Access Compliance Report Public Rights-of-Way (Curb Ramps)

Main Street: COLERIDGE_DR Cross Street: FOSTER_RD Location: S

ADA ID: RPAT211202130329 Ramp Type: Type 1 - Perpendicular Diagonal Initial Pass/Fail: Pass Overall Compliance: No Severity Score: 4

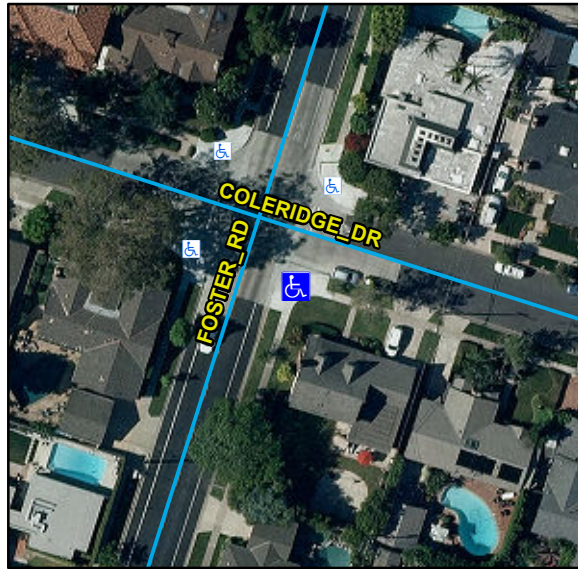
Remove & Replace Landing.

R304.2.1, STD 1115
